Edwin I. Hatch Nuclear Plant - Unit 2
Response to Request for Additional Information
Regarding Core Shroud Modification

Edwin I. Hatch Nuclear Plant - Unit 2
Response to Request for Additional Information
Regarding Core Shroud Modification

By letter dated August 17, 1995, the Nuclear Regulatory Commission (NRC) staff requested Georgia Power Company (GPC) to provide additional information regarding the Core Shroud Modification scheduled for installation during the Fall 1995 Unit 2 refueling outage. The NRC questions and GPC's response to the twenty-five questions are provided below:

TITLE	SHROUD SUPPORT WELD PLATE DETAIL
-------	----------------------------------

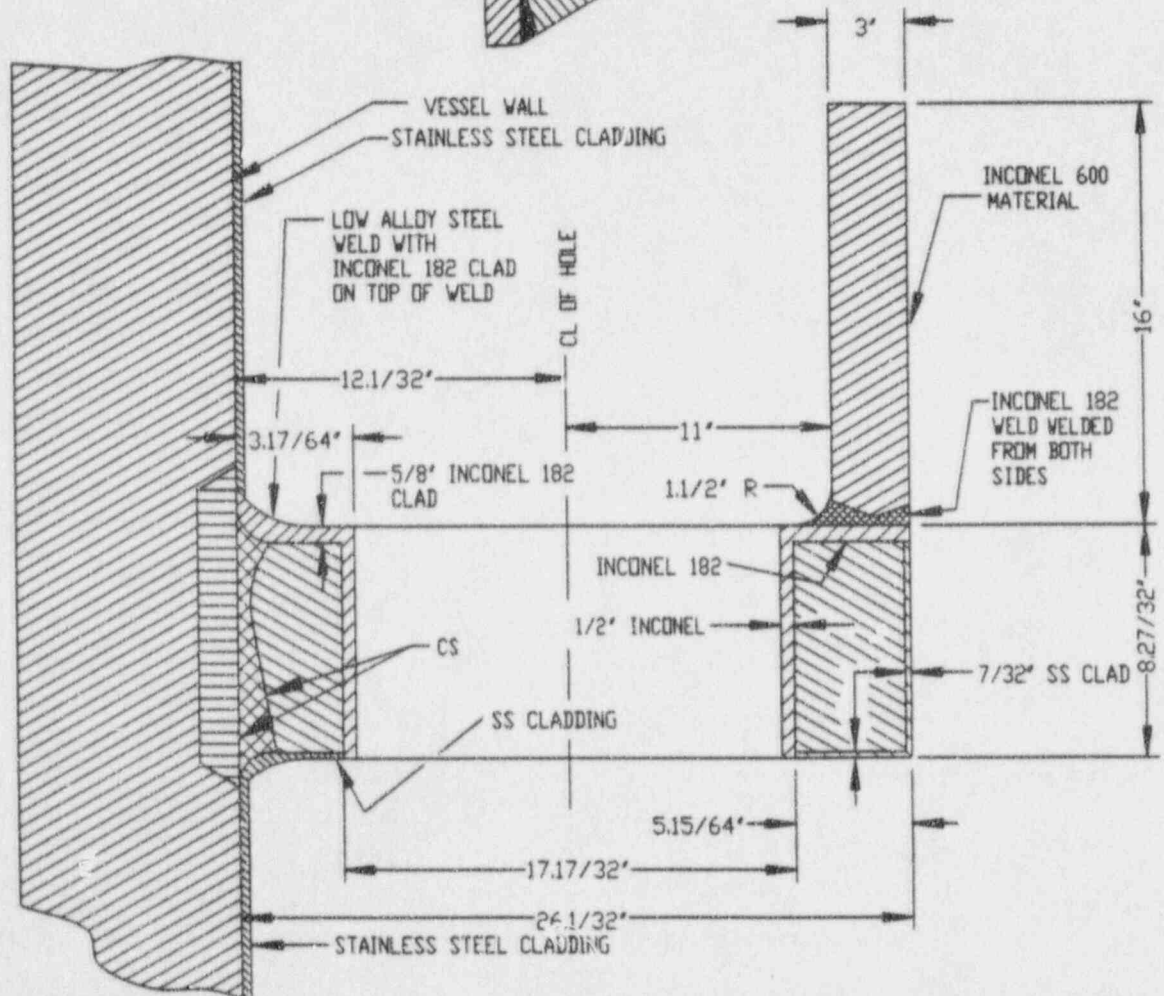
Provide drawings showing the details of the shroud support plate and its attachment to the shroud. During a postulated faulted event of a DBE plus RLB LOCA, state the amount of lateral motion that is projected to occur at the core support plate. Indicate how control rod insertability is expected to be maintained during this accident.

The following sketch (2-BN-6-2) provides the details of the shroud support plate. During a postulated faulted event of a DBE plus RLB LOCA, the maximum amount of transient lateral motion that is projected to occur at the core support plate is 0.24 in.. This is small compared to the allowable value of 1.50 in. for faulted events. Thus there is large margin for assuring control rod insertability.

FIGURE Q12-1
Details of the Shroud Support Plate Analysis Model

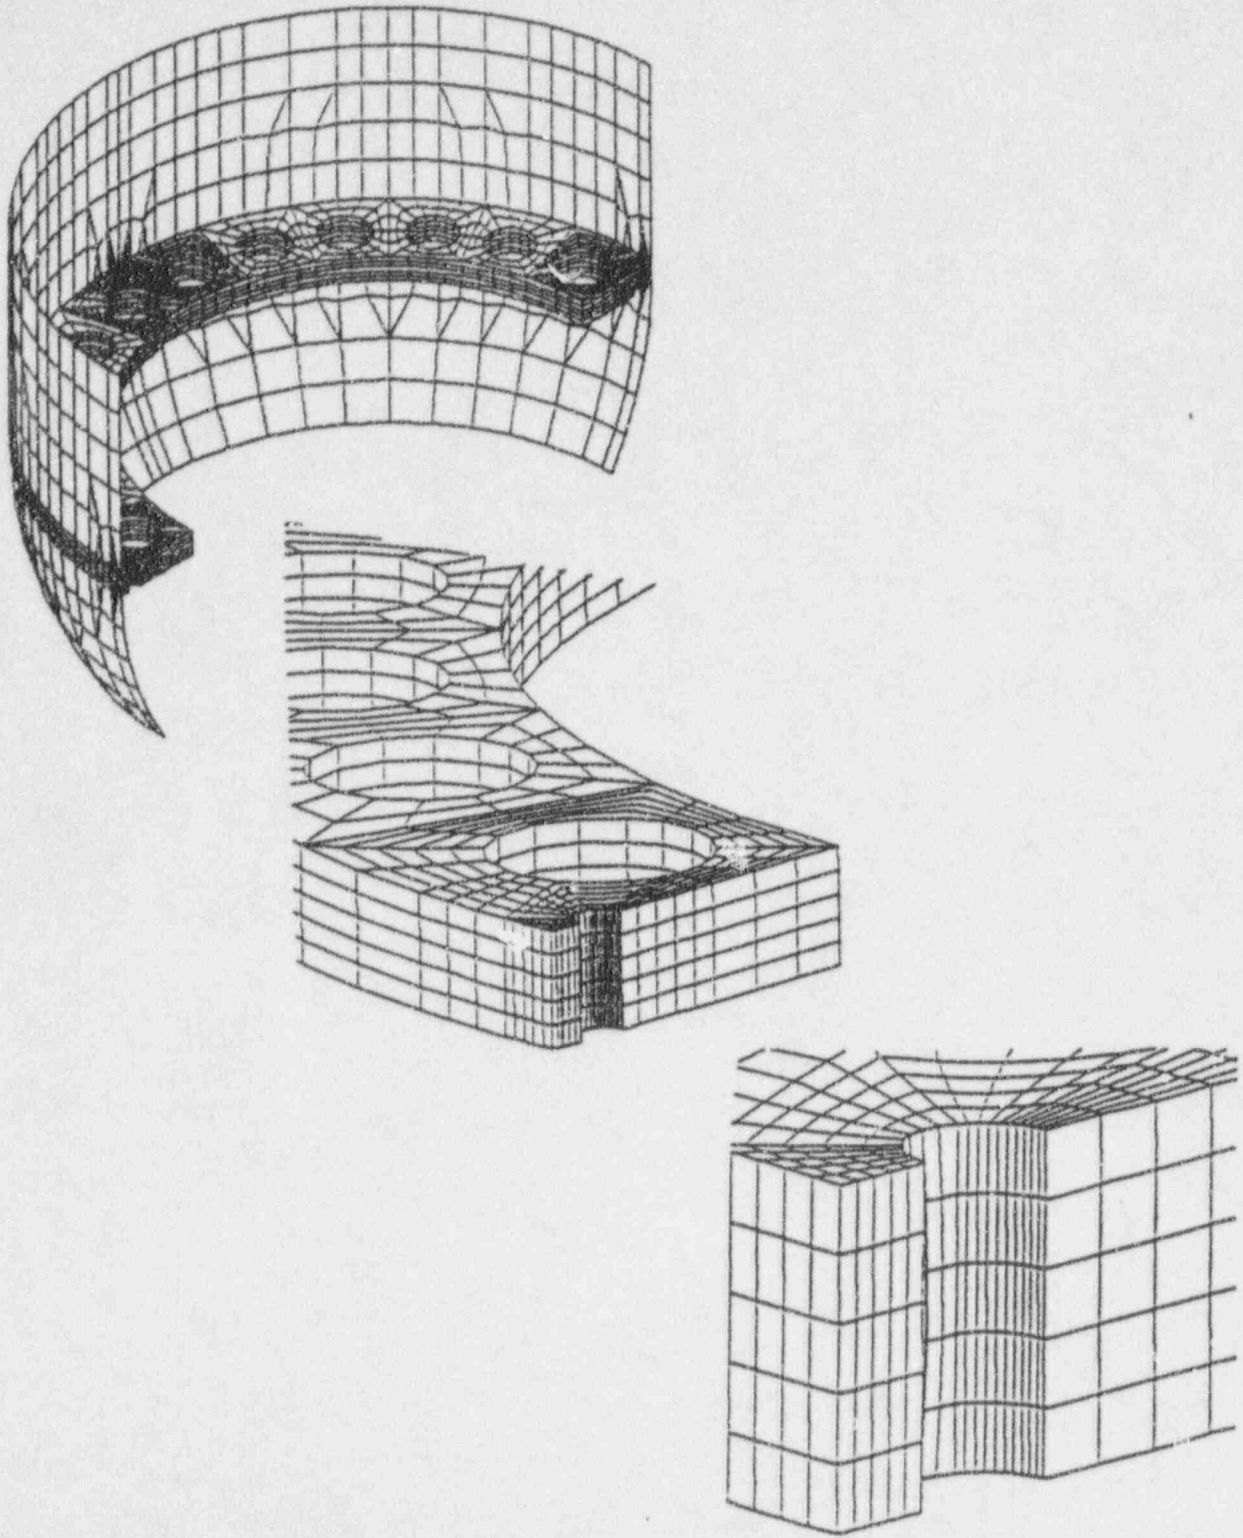
Provide a summary of the ANSYS output which led to the results shown as shaded areas in Figure 7-2, Shroud Repair Hardware Analysis Report (GENE-B11-00637-002) for the Shroud Support Plate analysis.

Figure 7-2 in the report shows the analysis model rather than analysis results. Some areas of the model appear shaded because of the larger node and element density in these regions. Expanded views of the model are shown in the attached Figure Q12-1.

Figure Q25-1

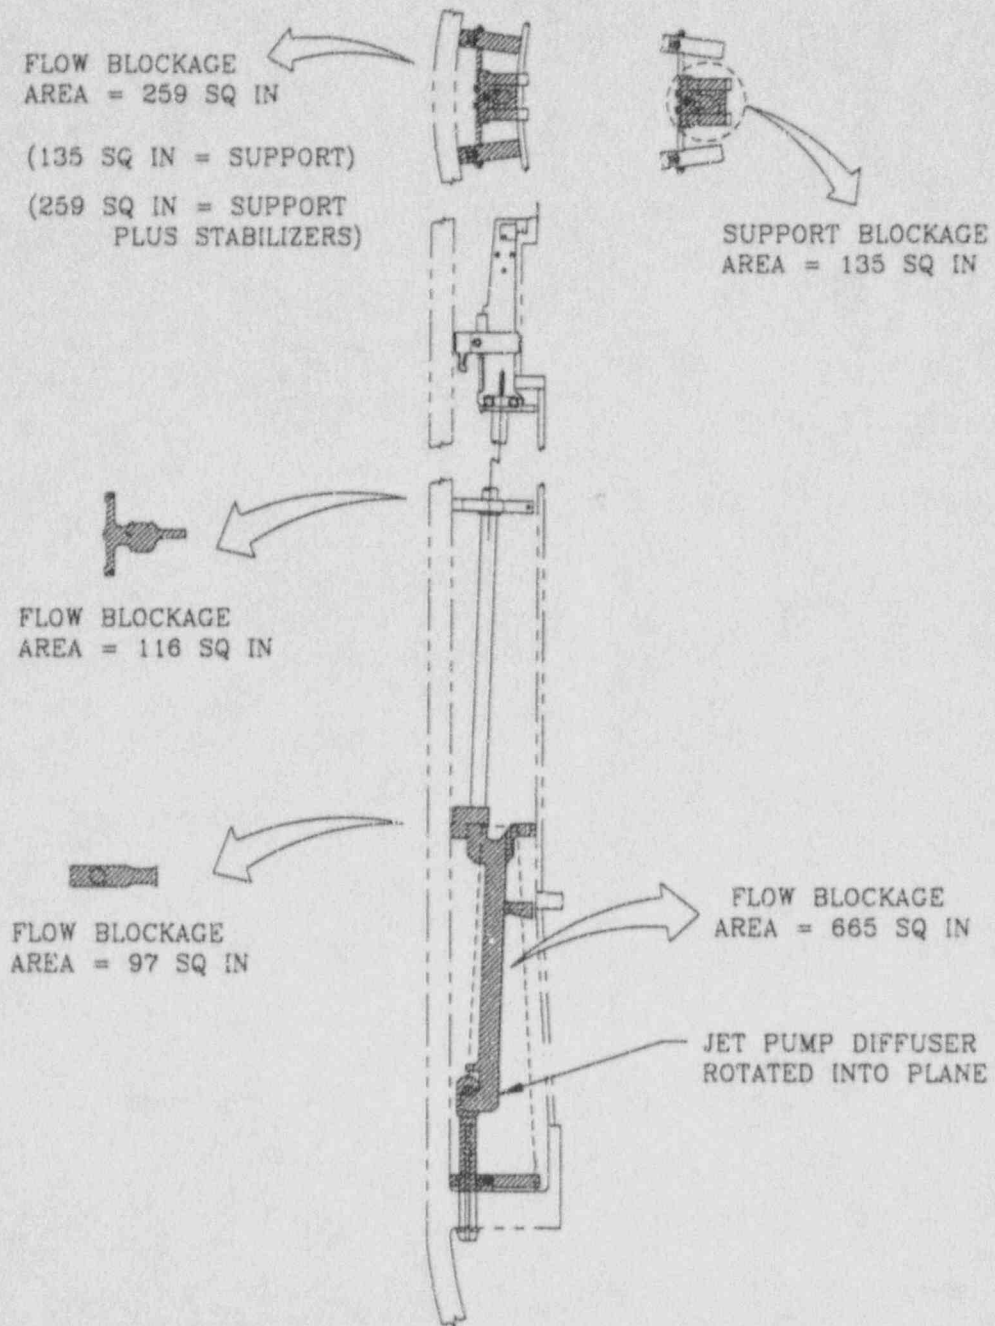
In the Core Shroud Stabilizer Design Submittal, dated July 3, 1995, and in GE Responses to NRC Questions for Unit 2 Shroud Repair, GENE-B11-00637-006, Rev. 0, the flow characteristics of the downcomer with the four stabilizers installed were analyzed. In order to compare this flow area analysis with that of other projects, please provide the analysis with respect to pre-repair net flow area and post-repair net flow area. Discuss the increase in pressure drop through the downcomer due to reduction in flow area and its effect on the recirculation flow of the reactor.

The closest distance between the jet pump suction nozzle inlet and the 3.75 in. diameter stabilizer tie rod is 5.7 in. At this distance, the predominately downward flow distribution near the jet pump nozzle will not be significantly affected.

The smallest vessel-to-shroud annulus plan area (downcomer flow area) is at the shroud head flange elevation. This flow area, based on the as-built vessel diameter and the items which block this annulus are summarized in the table below. The additional blockage at this elevation due to the shroud repair upper supports, is about 6 percent of the pre-repair minimum downcomer area. This blockage only applies to the short vertical distance corresponding to the shroud head lugs.

A second elevation having a less restrictive net flow area was also considered. This area is located at the upper stabilizers which are adjacent to the top guide wedges. Based on the as-built vessel diameter, this flow area and the items which block this annulus are summarized in the table below. The net flow area at this elevation, with the inclusion of blockage introduced by the shroud repair, is about 3 percent less than the pre-repair minimum downcomer area. This blockage applies only over the 5 in. height of the upper stabilizers. The additional horizontal flow blockage from shroud stabilizer hardware at other elevations in the shroud-to-vessel annulus will be less than this area. The impact of the additional flow blockage on the recirculation system loop hydraulic resistance, loop pressure drop, and coolant flow rate is estimated to be negligible.

During a recirculation suction line break there may be a significant horizontal flow component in the lower vessel annulus. The four lower stabilizer springs are each located 45° from the recirculation outlet nozzle. The vertically oriented flow blockage area of the lower spring assembly is shown in Figure Q25-1. By inspection the net vertical flow area at the lower stabilizer spring locations is significantly greater than the net area at each of the 20 jet pump diffusers. Thus, the blockage effect of the lower springs will have an insignificant effect on recirculation line break blowdown calculations. Hence, emergency core cooling system performance is not impacted as a result of the flow blockage associated with the stabilizer mechanisms.
